9 October 2023

**Re: 84 MANOR ROAD
HOMEBASE MANOR ROAD
PUBLIC CONSULTATION ON AMENDED APPLICATION
LOCAL AUTHORITY REF: 19/0510/FUL - GLA REF: 4795**

Block A, Core A: a 45cm increase to the south

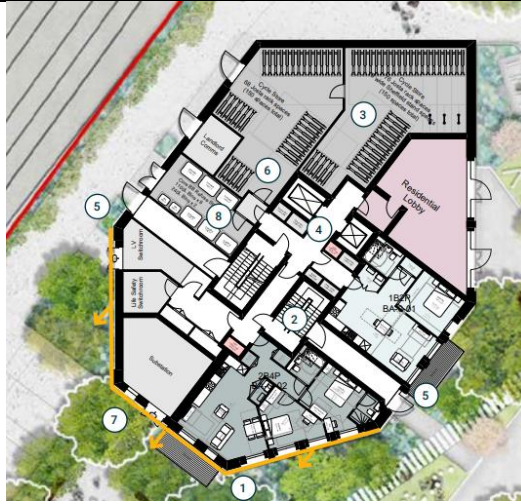
To accommodate the second staircase, the internal layouts of the buildings have been altered, and an increase in building footprints (yellow line as illustrated in the following images).
